# London Luton Airport Expansion

**8.118 Applicant's Response to Issue Specific Hearing 4**  
**Action 7 - Updates on Road Safety Audits**

Application Document Ref: TR020001/APP/8.118

Figure 2.1: Locations of Problems Identified within the Audit

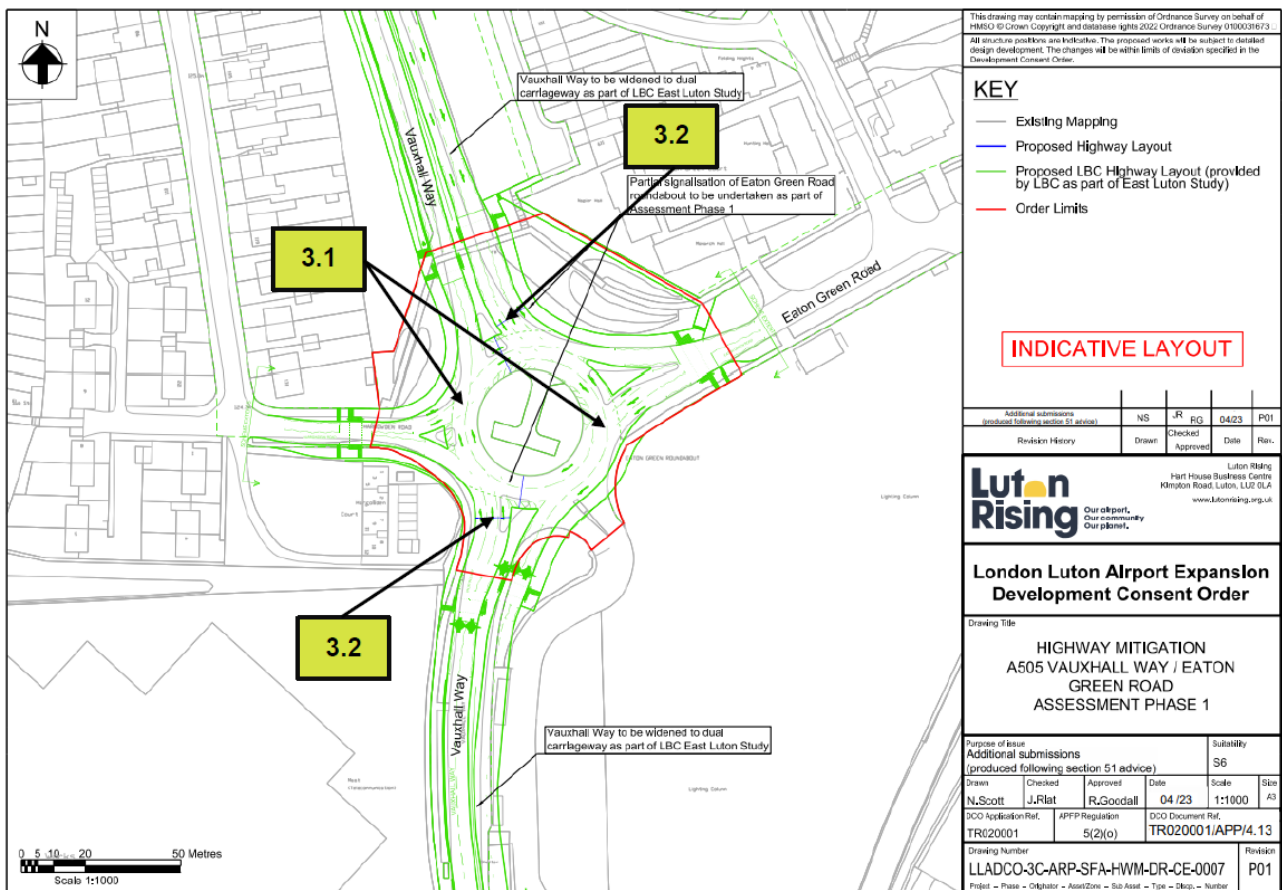
Ref.	RSA Problem	RSA Recommendation	Design Organisation Response	Overseeing Organisation Response	Agreed RSA Action
3.1	The stacking distance between successive signal stop lines is quite short, which could lead to vehicle queues extending across the Harrowden Road and Eaton Green Road entries to the roundabout. As a result, collisions could occur as road users attempt to weave through queues or change lane suddenly.	It should be ensured that the road layout and traffic signalling strategy is suitable to prevent vehicles queuing across entry arms to the roundabout.	Accepted. The operation of the signals would be optimised to ensure the efficient operation of the junction and would include consideration of queue lengths within the circulatory carriageway of the roundabout.

Figure 2.1: Locations of Problems Identified within the Audit

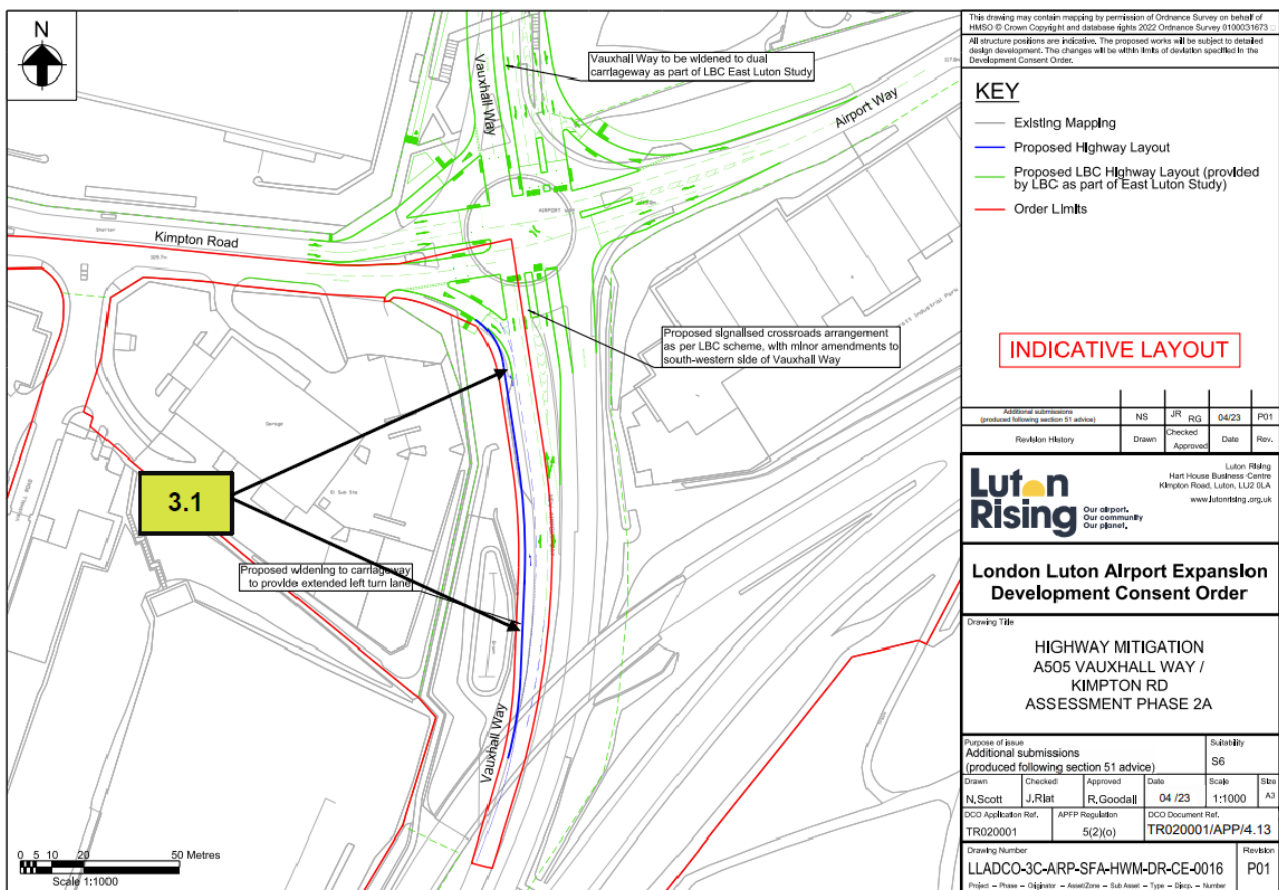
Ref.	RSA Problem	RSA Recommendation	Design Organisation Response	Overseeing Organisation Response	Agreed RSA Action
3.1	There are lamp columns and trees within the verge that will be closer to the edge of carriageway when the road is widened. A temporary vertical concrete barrier is also present, but it is not clear whether this will be retained. If not, the lamp columns and trees could present a roadside hazard to road users if they lose control and collide into the objects. Injuries could be serious if vehicles are brought to an abrupt halt or redirected violently.	A suitable vehicle restraint system should be provided, unless the lamp columns are replaced by passively safe systems and any mature trees removed that will be close to the edge of carriageway.	Accepted. This would be addressed at the detailed design stage.

Figure 2.1: Locations of Problems Identified within the Audit

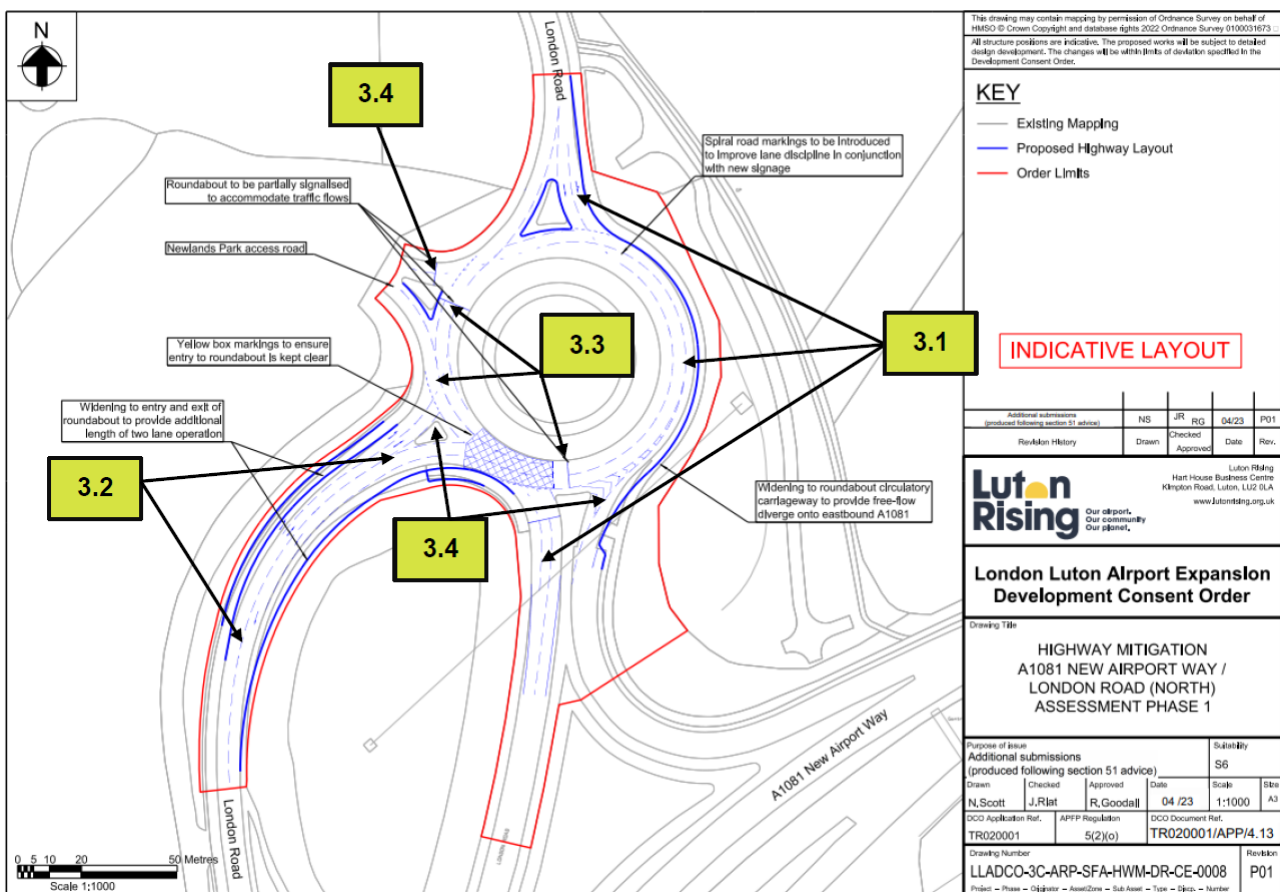
Ref.	RSA Problem	RSA Recommendation	Design Organisation Response	Overseeing Organisation Response	Agreed RSA Action
3.1	Road users may not be able to anticipate which lanes to use to reach their intended destination. For example, on the A1081 approach, road users may use the middle lane to reach London Road (north) rather than the designated offside lane. On the London Road southbound approach, road users may use the offside lane to reach the A1081 (which they can currently), instead of using the nearside lane only. If road users find that they are in the incorrect lanes, side swipe and lane change collisions could occur.	Lane destination signs and road markings should be provided at strategic locations to inform road users of the correct lanes to use.	Accepted. Lane markings and signage would be provided to clarify which destinations are reached from each approach lane. This would be addressed at the detailed design stage.

Ref.	RSA Problem	RSA Recommendation	Design Organisation Response	Overseeing Organisation Response	Agreed RSA Action
3.3	The stacking distance between successive signal stop lines is quite short, which could lead to vehicle queues extending across the London Road southern entry to the roundabout. As a result, collisions could occur as road users attempt to weave through queues or change lane suddenly.	It should be ensured that the road layout and traffic signalling strategy is suitable to prevent vehicles queuing across entry arms to the roundabout.	Accepted. The operation of the signals would be optimised to ensure the efficient operation of the junction and would include consideration of queue lengths within the circulatory carriageway of the roundabout.

3.4	The widening of the roundabout could make crossing movements more hazardous for pedestrians and cyclists, especially at times of high vehicle flows (peak times) or when speeds could be higher at off-peak times. This could be a particular issue on the London Road southern arm and on the A1081 exit arm. On the Newlands Park access entry to the roundabout, the position of the signal stop line could make it difficult to provide a crossing point. Vulnerable road users could be at increased risk of being struck by vehicles under such circumstances.	It should be ensured that the pedestrian and cycle crossing points will be safe to use (for example, controlled crossings may be beneficial at some locations).	Noted. The proposed realignment on the A1081 exit arm increases the crossing distance by approximately 1.0m and could be reduced at the detailed design stage to minimise any additional crossing distance.  The pedestrian demand on the London Road (south) exit arm is likely to be very low, and the proposed signalisation of the A1081 arm should create gaps in the traffic for pedestrians to cross. In addition, the widening to the London Road exit is c1.5m and would only add c.1 second to the crossing time for pedestrians.

Ref.	RSA Problem	RSA Recommendation	Design Organisation Response	Overseeing Organisation Response	Agreed RSA Action
			The position of the stop line at the exit from Newlands Park would be adjusted to accommodate a pedestrian crossing at the detailed design stage.

Figure 2.1: Locations of Problems Identified within the Audit

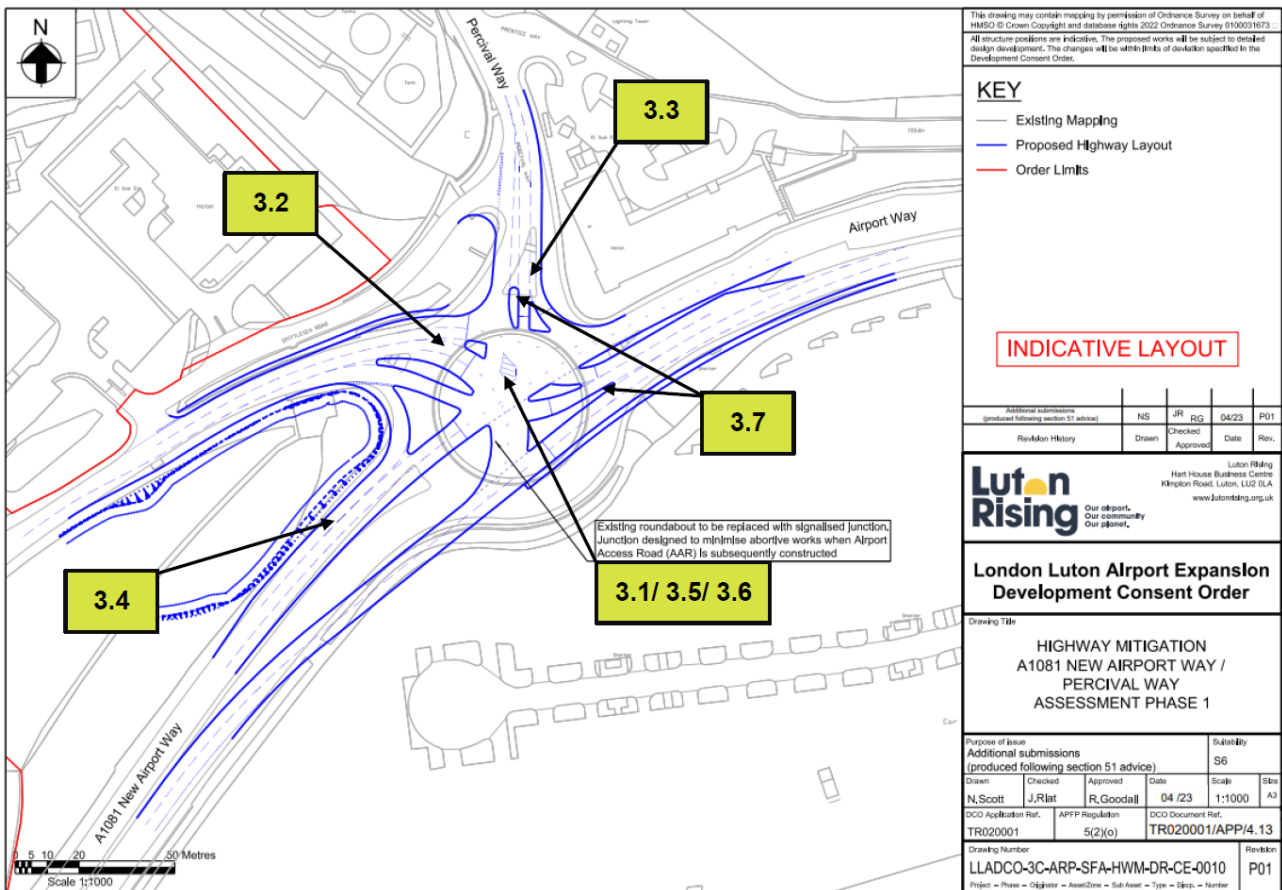
Ref.	RSA Problem	RSA Recommendation	Design Organisation Response	Overseeing Organisation Response	Agreed RSA Action
3.1	It was noted that the existing roundabout for New Airport Way and Percival Way is on a steep gradient which slopes away from the north side. With the introduction of the signalised junction there could be a level difference between each approach, which could create an adverse camber for vehicles turning at the junction. This could increase the risk of loss of control collisions and could cause larger, high sided vehicles to turn over.	The levels should be checked for each approach ensuring a level junction platform with no adverse cambers for vehicle turning movements.	Accepted. It is accepted likely that some regrading would be required on the approaches to and within the junction. This would be addressed at the detailed design stage.

Figure 3.1: Swept Paths - Frank Lester Way / Eaton Green Road

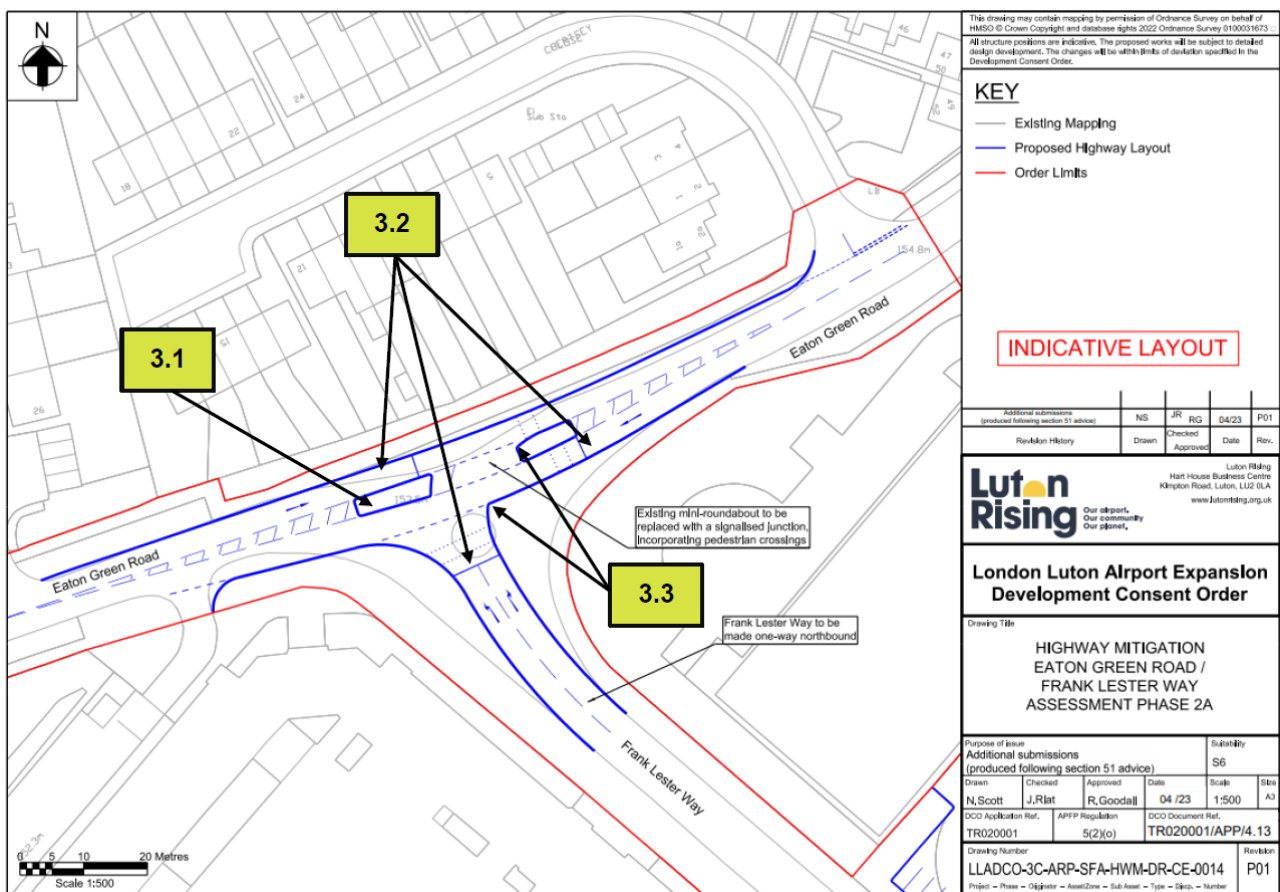
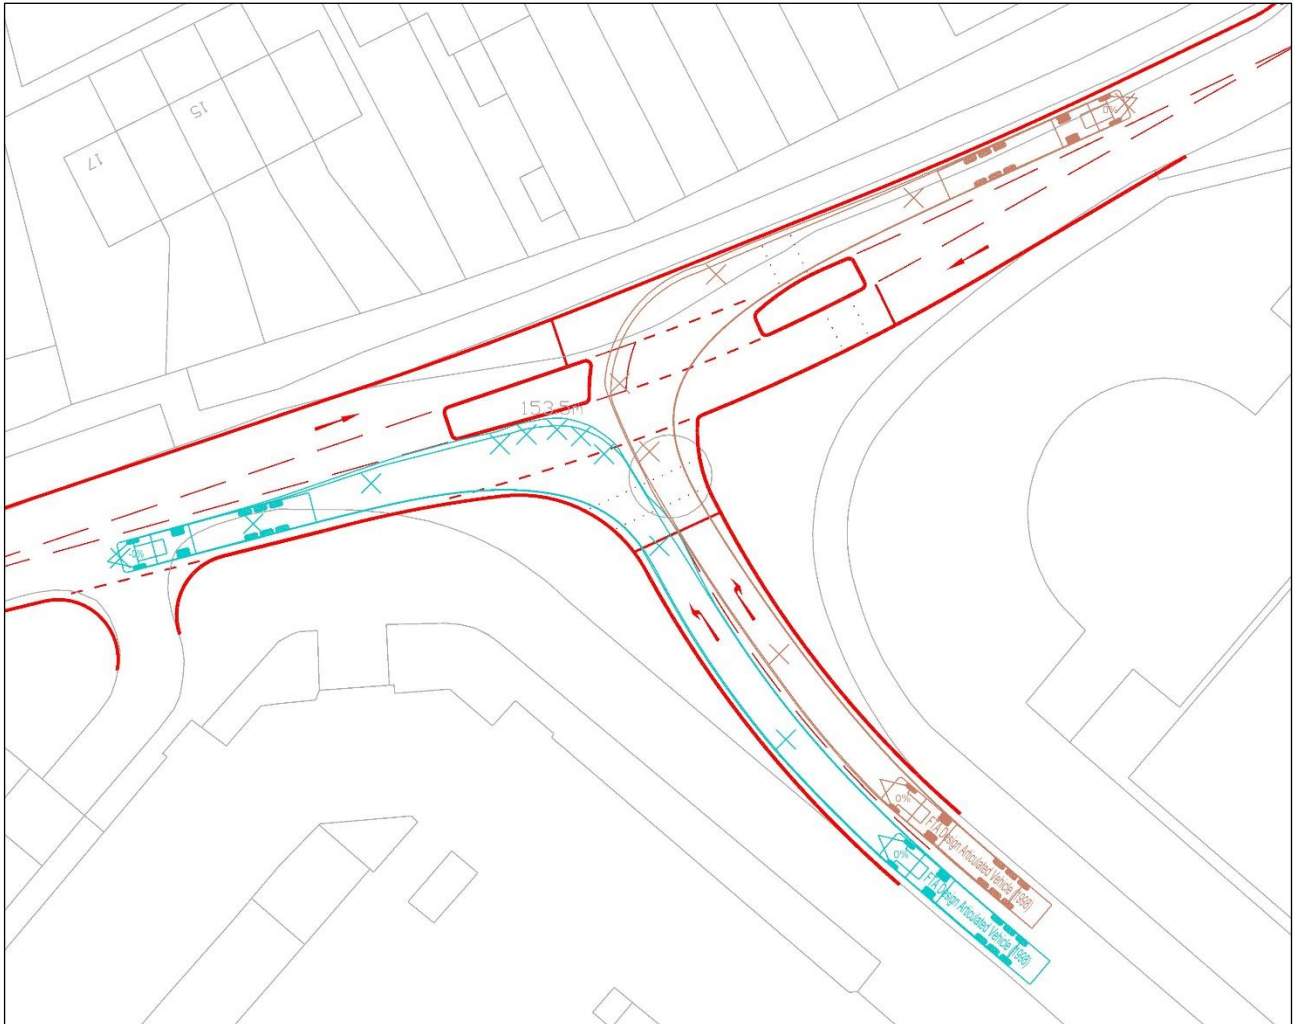
Ref.	RSA Problem	RSA Recommendation	Design Organisation Response	Overseeing Organisation Response	Agreed RSA Action
	result, they may mount the kerbs or strike street furniture, creating a hazard to other road users or pedestrians walking along the footway.	geometry of the junction amended if required.	into Eaton Green Road was achievable for vehicles including articulated HGVs and buses – see Figure 3.1

3.2.1 Figure 3.1 above shows the swept path analysis for 16.5m articulated HGV manoeuvres at the proposed signalised junction between Frank Lester Way and Eaton Green Road.

Figure 3.1: Swept Paths - Eaton Green Road / Lalleford Road

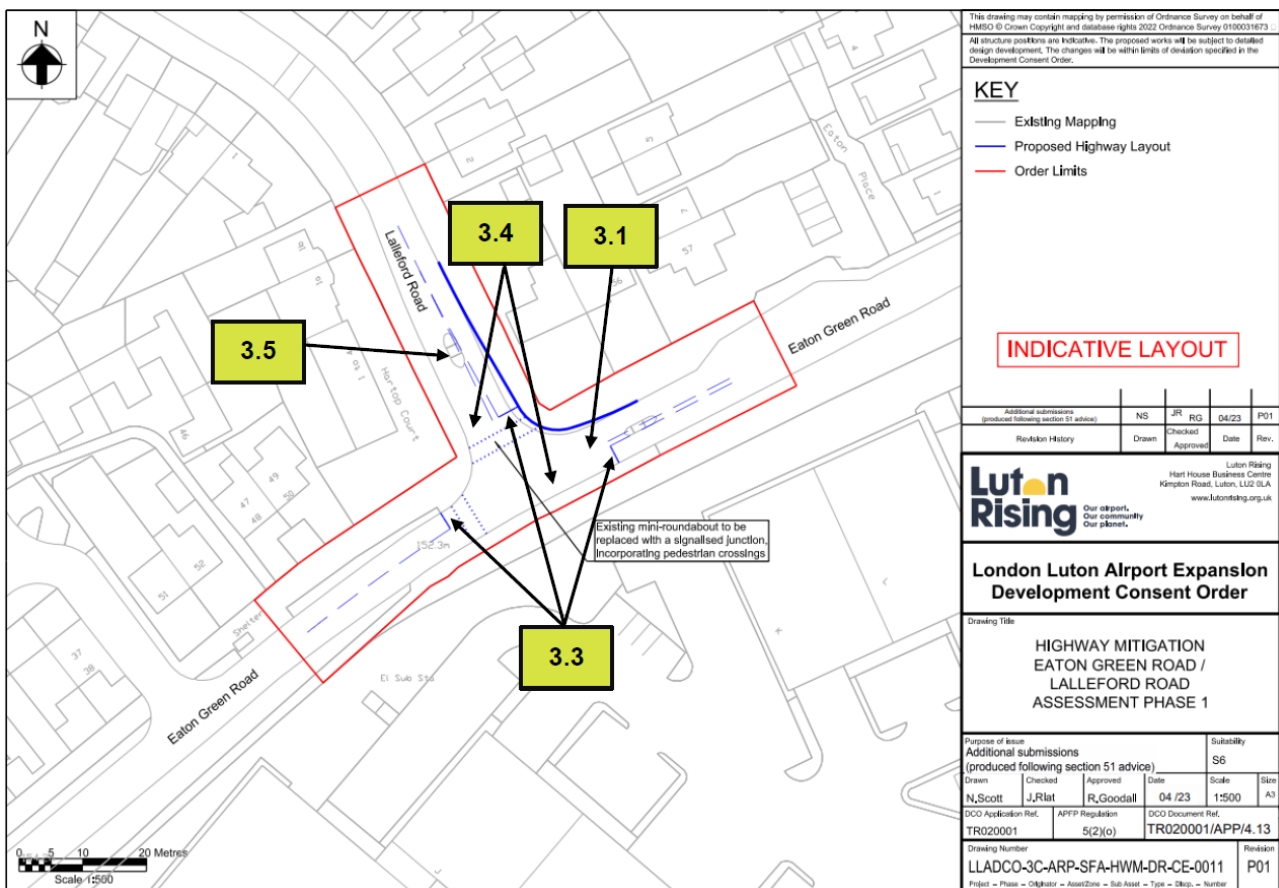
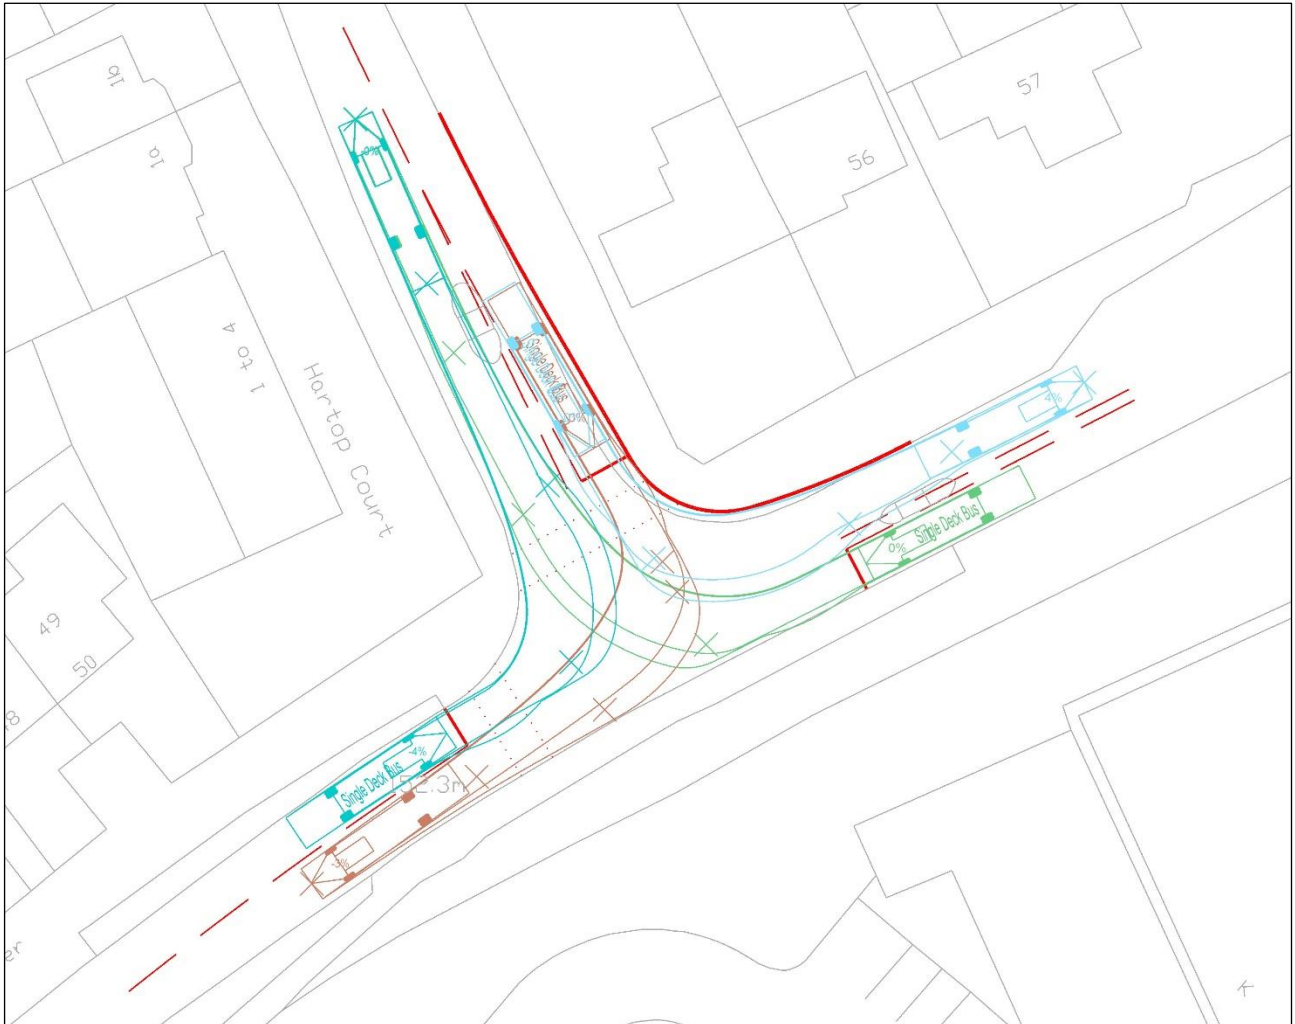
Ref.	RSA Problem	RSA Recommendation	Design Organisation Response	Overseeing Organisation Response	Agreed RSA Action
	Road is a bus route). As a result, large vehicles may mount the kerbs or strike street furniture, creating a hazard to other road users or pedestrians walking along the footway.	position of the stop lines adjusted if required.	to ensure that all manoeuvres can be accommodated without overrunning stop lines – see Figure 3.1.

3.2.1 Figure 3.1 above shows the swept path analysis for 12m single deck buses at the proposed signalised junction between Eaton Green Road and Lalleford Road.
